UNITED STATES PATENT AND TRADEMARK OFFICE

APPLICATION NO.	FILING DATE	FIRST NAMED INVENTOR	ATTORNEY DOCKET NO.	CONFIRMATION NO.
10/533,008	04/28/2005	Shuji Tabuchi	10873.1587USWO	1648
53148 7590 02/08/2008 HAMRE, SCHUMANN, MUELLER & LARSON P.C. P.O. BOX 2902-0902 MINNEAPOLIS, MN 55402			EXAMINER KAYRISH, MATTHEW	
			ART UNIT 2627	PAPER NUMBER
			MAIL DATE 02/08/2008	DELIVERY MODE PAPER

Office Action Summary

DETAILED ACTION

FIG. 5A.

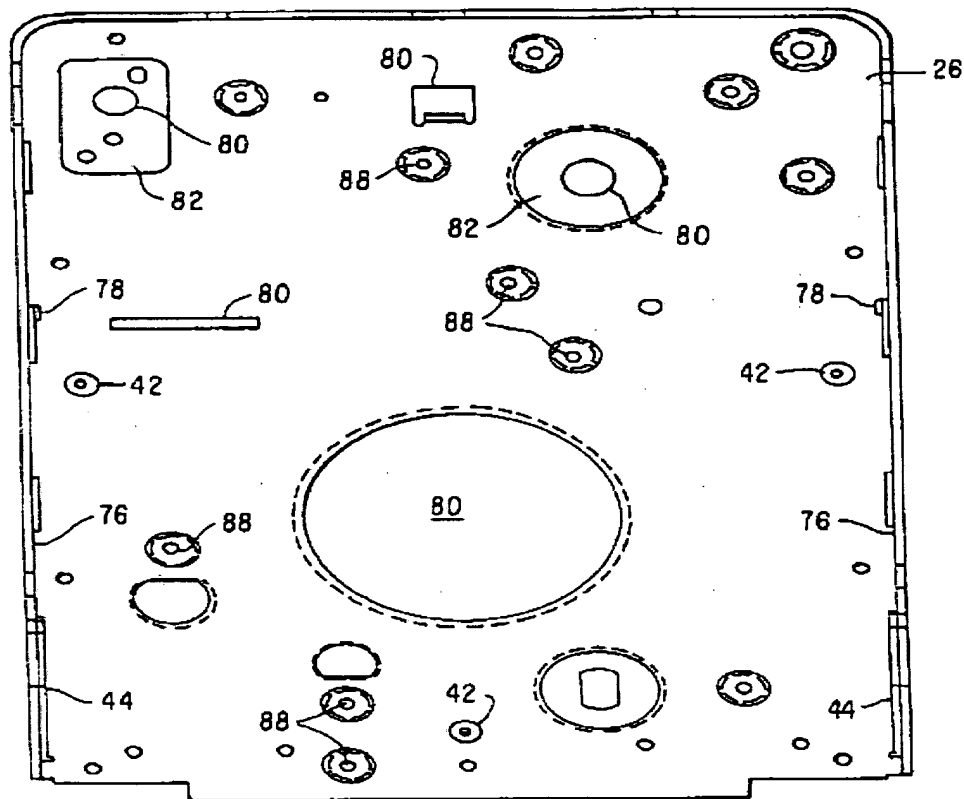
A case comprising a bottom plate in a substantially rectangular shape (figure 5A, item 26), and a first side plate and a second side plate (figure 5A, items 76) rising respectively from a pair of border lines forming the bottom plate and facing each other (figure 5B, plates face each other), either one edge side orthogonal to the pair of border

Wherein, on an inner surface of the first side plate where the first side plate and the second side plate face each other, a first rib having a top face parallel to the inner surface of the first side plate is provided (figure 5A, item 78), with a height D1 between the inner surface of the first side plate and the top face of the first rib (figure 5A);

On an inner surface of the second side plate where the second side plate and the first side plate face each other, a second rib having a top face parallel to the inner surface of the second side plate is provided so as to face the first rib (figure 5A below), with a height D2 shorter than the height D1;

On the inner surface of the first side plate on the entrance side with respect to the first rib, a first protrusion having a top face parallel to the inner surface of the first side plate is provided with a height D3 shorter than the height D1 (figure 5A below); and

Both a spatial distance D4 between the top face of the second rib and the inner surface of the first side plate, and a spatial distance D5 between the top face of the first protrusion and the inner surface of the second side plate (figure 5A below) allow a width D6 of the insertion in a facing direction of the first side plate and the second side plate to be inserted with a loose fit (figure 7B, cartridge is loosely fit).

A third side plate rising from the other edge facing the entrance via the bottom plate, with the same height as that of the first side plate and the second side plate (figure 5A, item 26 has a back wall).
